**National Park Service  
Chesapeake & Ohio Canal National Historical Park  
Accessibility Review of Exhibits  
September 5-6, 2007  
U. S. Fish and Wildlife Service  
National Conservation Training Center**

**Improving Exhibits for Visitors with Disabilities  
Harpers Ferry Center Initiative to  
Enhance Programmatic Accessibility in Museum Exhibits**

**November 2007**

**Attachment 5 – Great Falls Tavern Visitor Center Tabletop with Aroma Chambers**

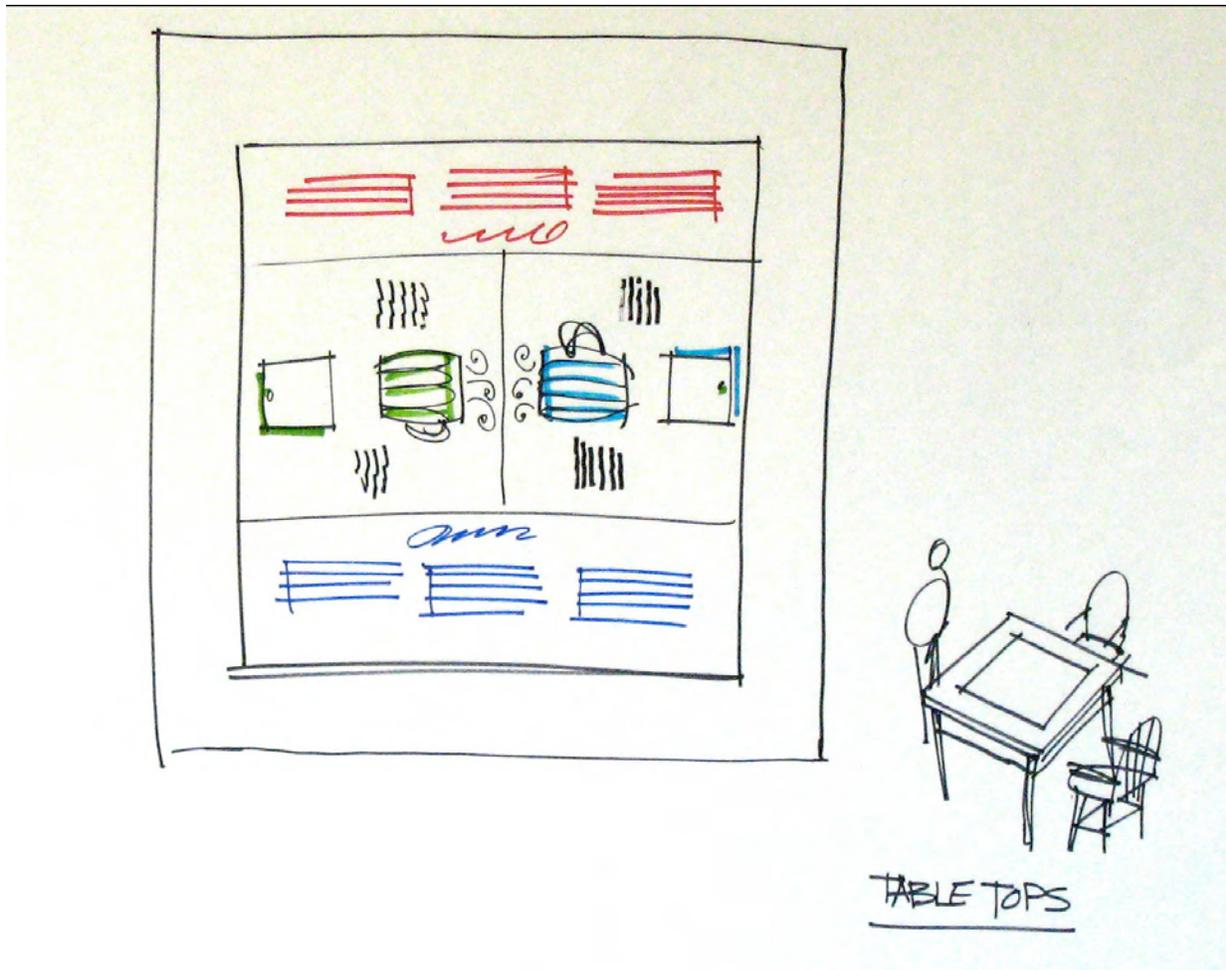
- Exhibit 17 – Label repeated on each side. One recipe with lift door to smell experience (cider, ginger). (Attachment 5)
- Exhibit 18 – Text split in two, opposing.

- Exhibit 19 – Text shortened, brought to bottom panel facing.
- Hands free audio. To be determined.
- Olfactory experience but not ambient (Attachment 5)

- 50% of chairs should have arms and backs. Yes.
- Table top displays are reachable by those with limited mobility – Maximum reach of 18”. (Attachment 5)

Exhibit 17 – EDX suggested redesigning “Dry Spell for the Tavern”, one of the tabletop exhibits to include aroma chambers. Lift doors set in the table surface and positioned next to graphics describing drink recipes can be raised to expose the aromas of non-alcoholic beverages served at Great Falls Tavern.

## Attachment 6 – Great Falls Tavern Visitor Center Orientation

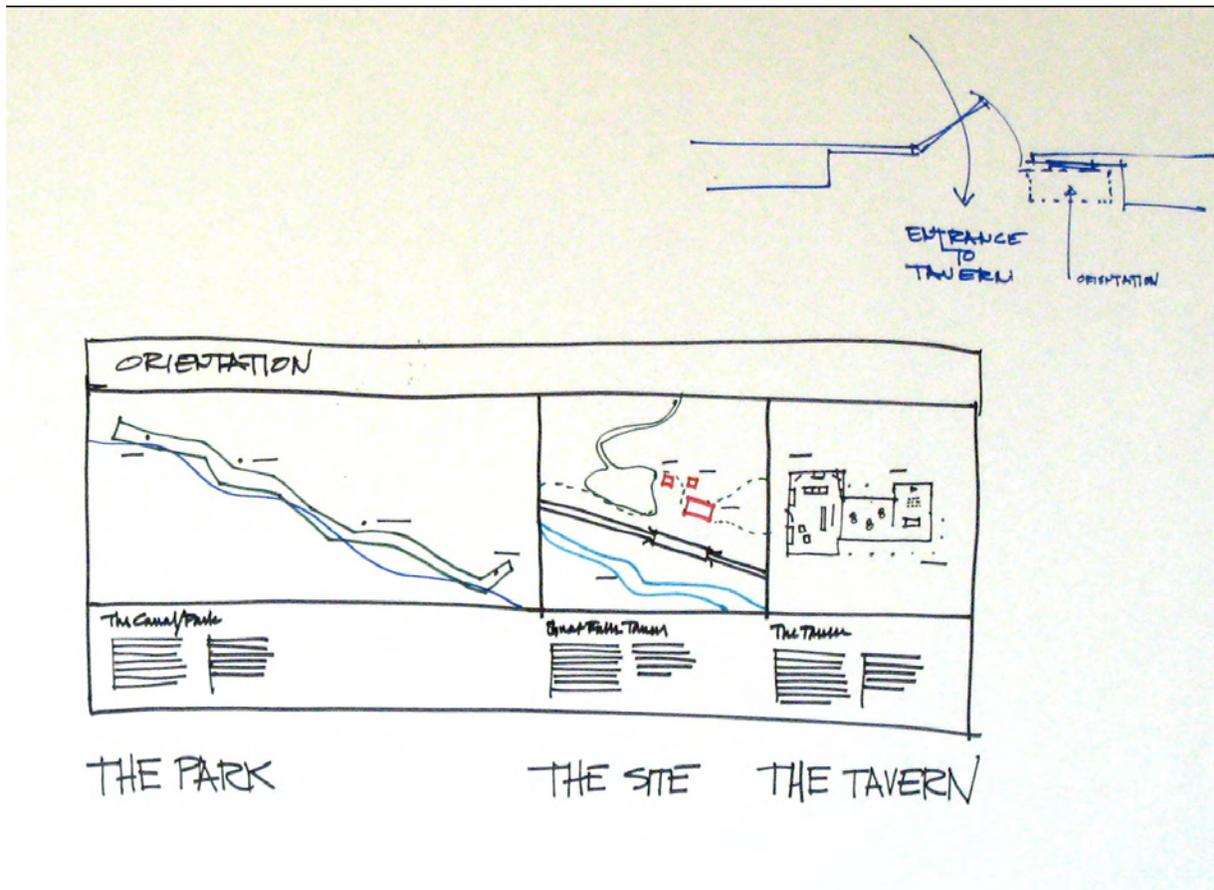
- Tactile models should reflect park story and utilize texture and dimension. Three tactile models one of the 184 mile park, one of Great Falls site (buildings, falls, parking lot) one of tavern. Tavern model shows exhibit elements to assist visitors with sight impairments to navigate through the exhibit. Above is a motion-activated sound cone that describes the three models. A barge becomes the scale. (Attachment 6)

New Exhibit (15) – EDX suggested a tactile orientation exhibit positioned near the entrance counter. This table top display would include three maps, one of the entire C&O Canal NHP, one of the Great Falls Tavern site including the locks, buildings and falls, and one of the interior of the visitor center. The visitor center map would include tactile representations of the three rooms and exhibits, and act as an initial guide to the space for both sighted and sight-impaired visitors. An audio program (sound cone) will be installed to describe what the visitor is touching. A miniature barge becomes the scale.

## Attachment 7 – Great Falls Tavern Potomac Watershed Model

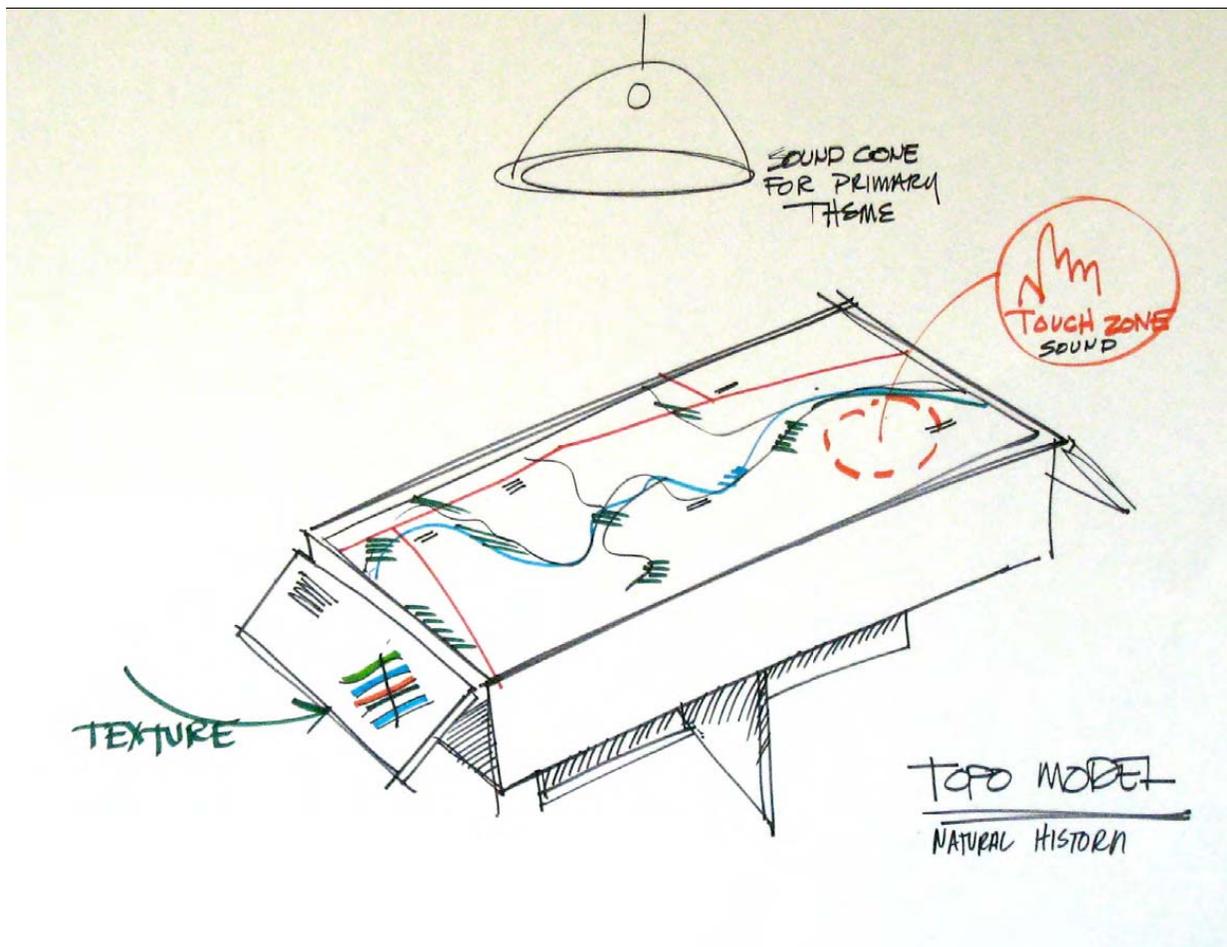
- Canal boat model needs to be tactile. Smaller model would be the whole. Larger model used to gather detail.
- Tactile model connected to audio description. Relief model of Potomac watershed. Touch-activated audio interpretation of recreation and natural history stories related to relief model. Reading rails on floods and geologic zones. Recessed river provide key to model. Zones with different textures. (Attachment 7)

**Exhibits 37** – To improve the Potomac Watershed Topographic Model, EDX suggested that the size of the model be reduced so a sight-impaired visitor could easily touch all parts of the model from one position. Either motion sensor or touch-sensitive technology will be added to the model. This technology will activate an audio program (overhead sound cone) that describes features on the model. It has yet to be determined if only one message or several messages, keyed to parts of the model, will be activated by visitor motion or touch. Maps on the two flanking reading rails will be made tactile.

**Exhibits 21 to 26 Life on the Canal** – Workshop participants recommended adding an audio feature to the central gallery of the center. In this gallery six full sized figures (touchable sculptures) represent individuals who lived and worked on the canal. An audio system that was either ambient and filled the entire space with one track or a set of six individual audio programs keyed to specific sculptures were discussed.

## Attachment 8 – Georgetown Visitor Center

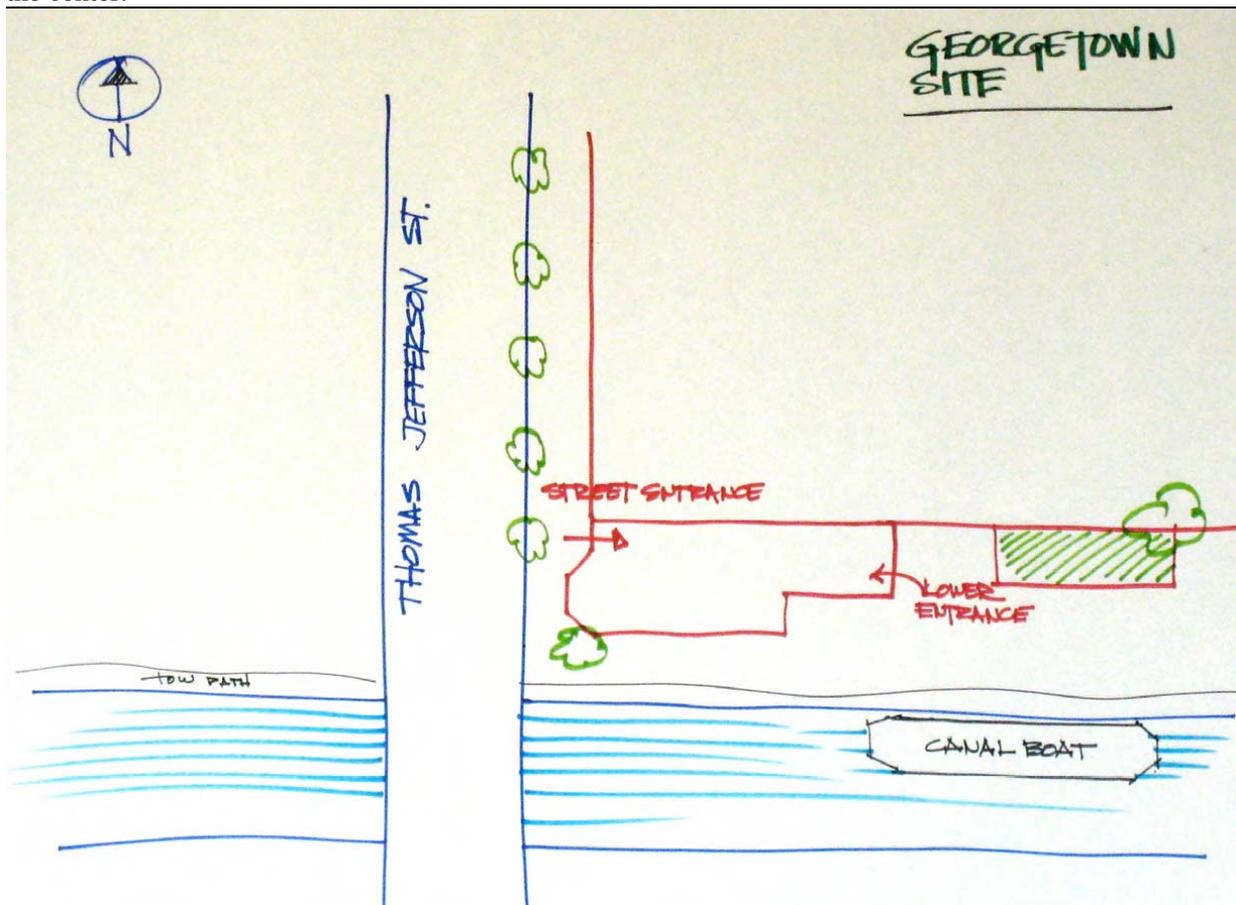
EDX reviewed the overall site plan of the Georgetown Visitor Center (Attachment 8) and presented options to address programmatic accessibility in the limited facility:

During the accessibility workshop it was determined that a reduction in the amount of content and redesign of content juxtaposition would be beneficial. Many participants were concerned with the overall square footage available to the center. 1<sup>st</sup> floor (ground) has 220 square feet, 2<sup>nd</sup> floor has 248 square feet. In addition, questions as to the user-friendliness of the existing chairlift were raised. EDX developed several preliminary design alternatives to meet these and other criteria discussed on the first day of the workshop.
